LINOTYPE IMPROVEMENT INFORMATION SHEET

NO. 250

PIVOTING FRONT ASSEMBLING GUIDE (MODEL 29-30)

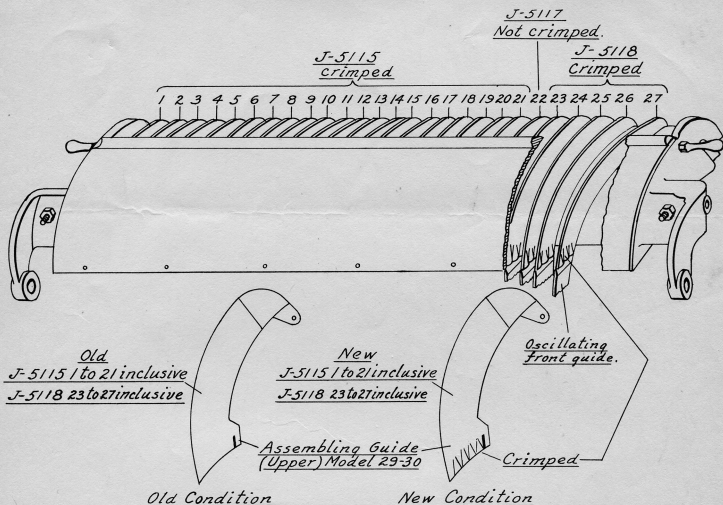
A crimp has been added to the lower end of the pivoting front assembling guides. This will provide a better guiding condition for the matrices into the oscillating front. It will also eliminate the possibility of matrices catching on the oscillating front guide, piling up and injuring the cover on the oscillating front.

Can be applied to outstanding Models 29-30 by substituting twenty one new J-5115 for positions 1 to 21 inclusive and five new J-5118 for positions 23 to 27 inclusive.
